Service Bulletin No. 415B

MODEL	J4500 Series	TYPE	Field Change Program	SECTION/GROUP	7-Electrical	DATE	Sept. 17, 2014
SUBJECT	DD13 ENGINE REGENERATION AT LOW AMBIENT TEMPERATURE						
CONDITIONS

THIS BULLETIN SUPERCEDES FIELD SERVICE BULLETIN 415 IN ITS ENTIRETY.

Figure 3.

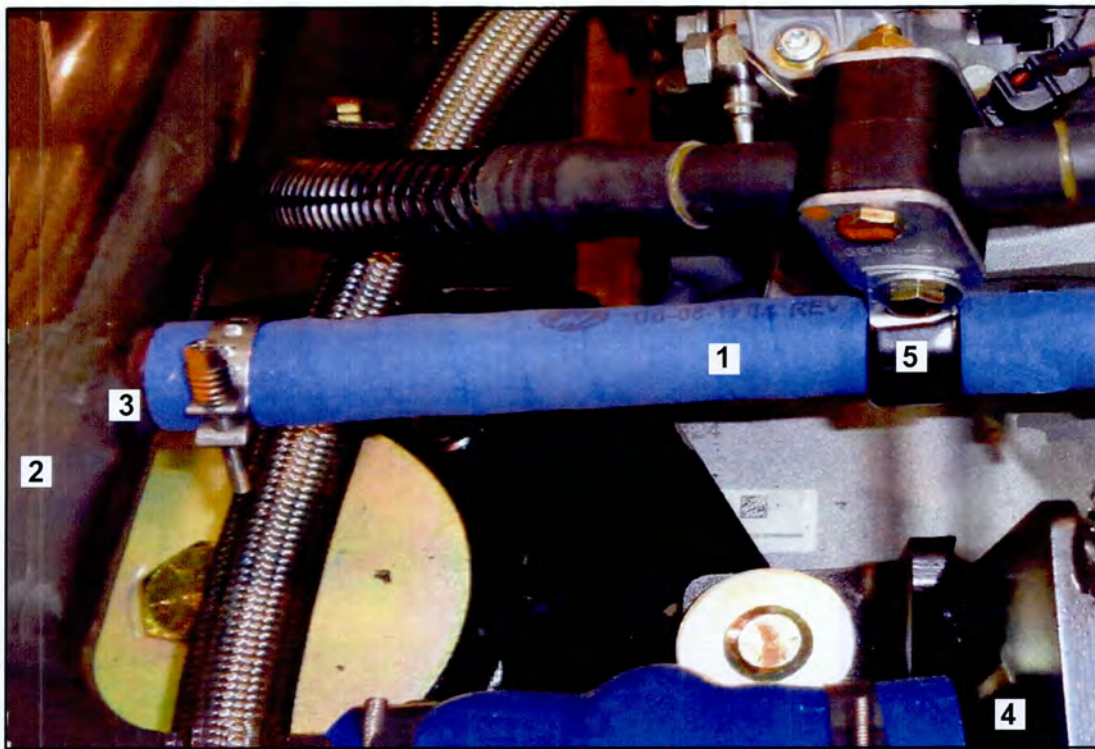
8. Locate the coolant hose (refer to Item 1 / Figure 3).
9. Locate the coolant hose line clamp (refer to Item 5 / Figure 3). Remove and retain the line clamp and mounting hardware.
10. Using a marker and tape measure, mark a line at the 9.50 and 14.00 inch point using Item 3 / Figure 3 as the starting point.

11. Using hose cutters and wire cutters, cut the hose jacket and wire framing at the lines made in Step 10. Discard the cut piece.

12. Orient the coolant bypass valve, p/n 16-16-1616, ensuring that the casting stamped "IN" port is facing towards the curbside of the coach. Slide one (1) stepless spring clamp, p/n 19-4-230, over both ends of the cut hose end. Install the valve utilizing the cut hose ends as shown in Figure 4. Orient and tighten the stepless spring clamp over the valve ports. Torque clamps to 12-14 in.-lbs.
13. Re-install the coolant hose line clamp (refer to Item 5 / Figure 3).

Figure 5.

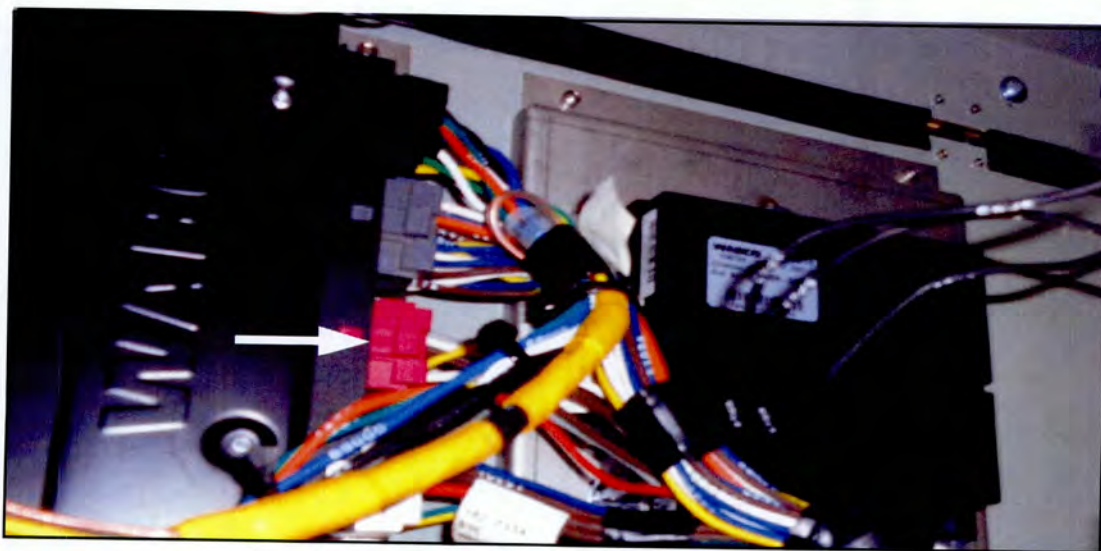
16. Locate the pink Plug 332 on the Wabco ABS module mounted on the hinged closing panel (refer to Figure 5). Locate spare wires SP43 and SP45 in the bundle six (6) inches back from the plug.

Figure 6.

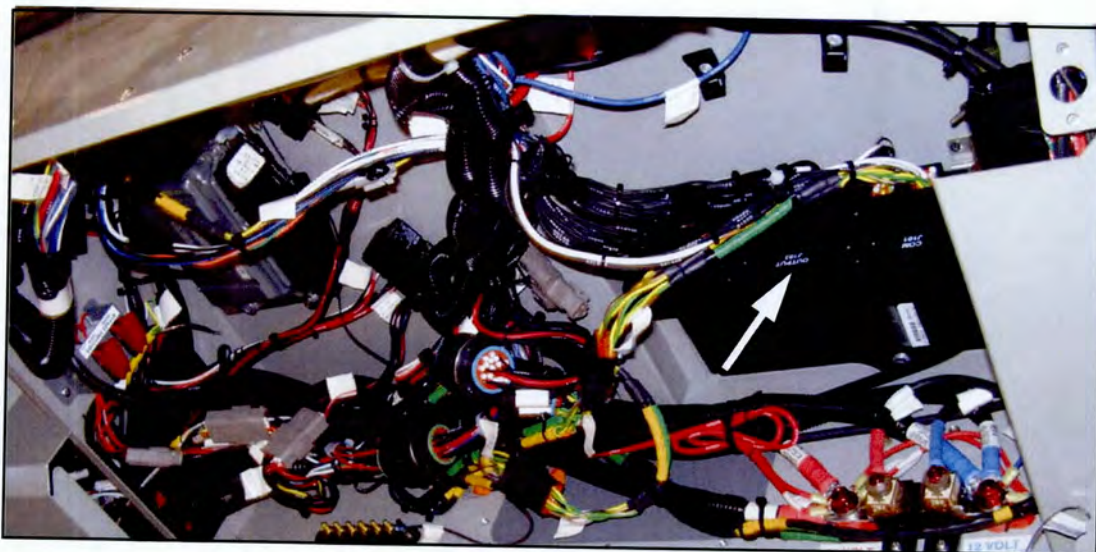
In the event that Pin 38 is populated utilize Pin 39. If Pin 38 and 39 are populated utilize Pin 36 when performing Step 17.

17. Locate Plug 103 on the Actia module (refer to Figure 6). Locate Pin 38 on Plug 103. Remove the plug from the cavity and populate Pin 38 with the pin end of the remaining cut section of the harness, p/n 07-12-4975.
18. Using wire strippers, strip the black wire 0.250 inch. Using solder, heat shrink and high heat loom, splice on black wire from harness, p/n 07-12-4975, to SP43.

Figure 7.

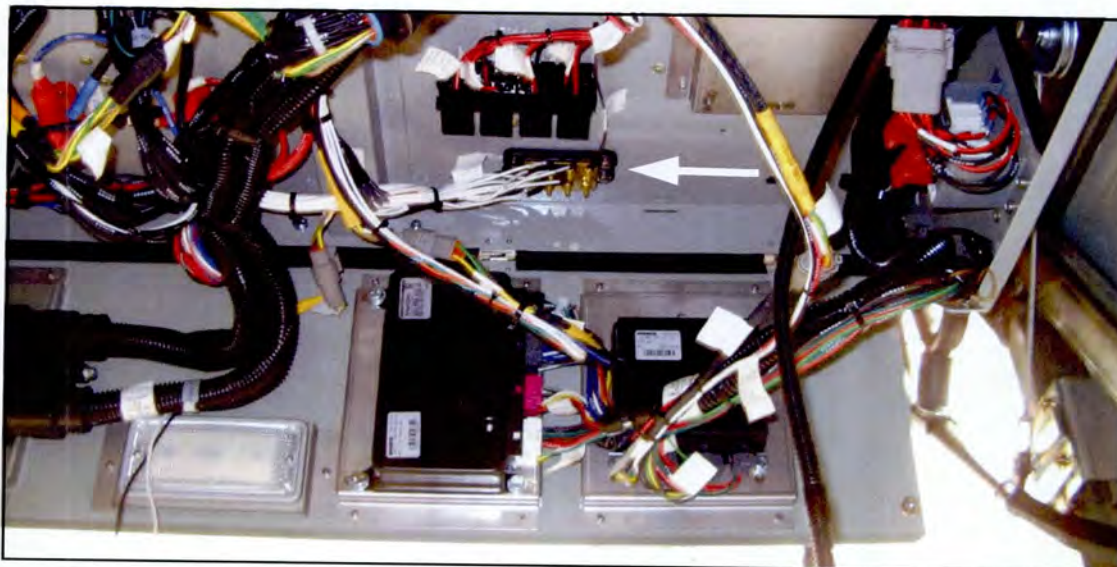
19. Route the ring terminal end of the remaining cut section of the harness, p/n 07-12-4975, to the ground block shown in Figure 7.
